2 COMMENTS AND RESPONSES

2.5 Individuals

Thank you for the opportunity to provide comments on the scope of the Corte Madera Creek Flood Risk Management Project Draft EIR.

Preliminary Floodplain Analysis (Work-in-Progress)
25-Year Event - Downtown Ross

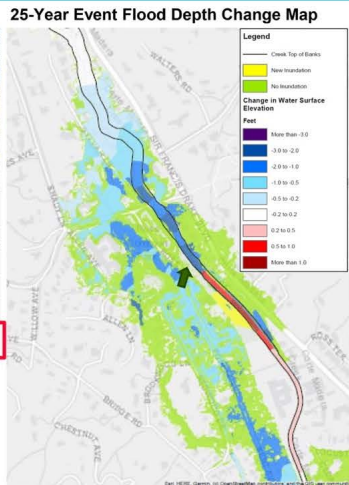
1. FISH LADDER REMOVAL ONLY PROVIDES MOST OF THE FLOOD BENEFIT

Removal of the Fish Ladder provides most of the flood benefit to the Town of Ross and, by comparison, at a relatively modest price. The County must provide a Fish Ladder Only Alternative, and eliminate the redo for Frederick Allen park portion.

The Frederick Allen Park makeover provides very little flood benefit to Ross, yet it comes at a very high price. Despite the fact that it is largely comprised of a DPW grant, the County has not clarified the percentage of overall budget vs. flood risk reduction benefit, but it is clear it uses a disproportionate number of resources to achieve very little additional Flood Benefit.
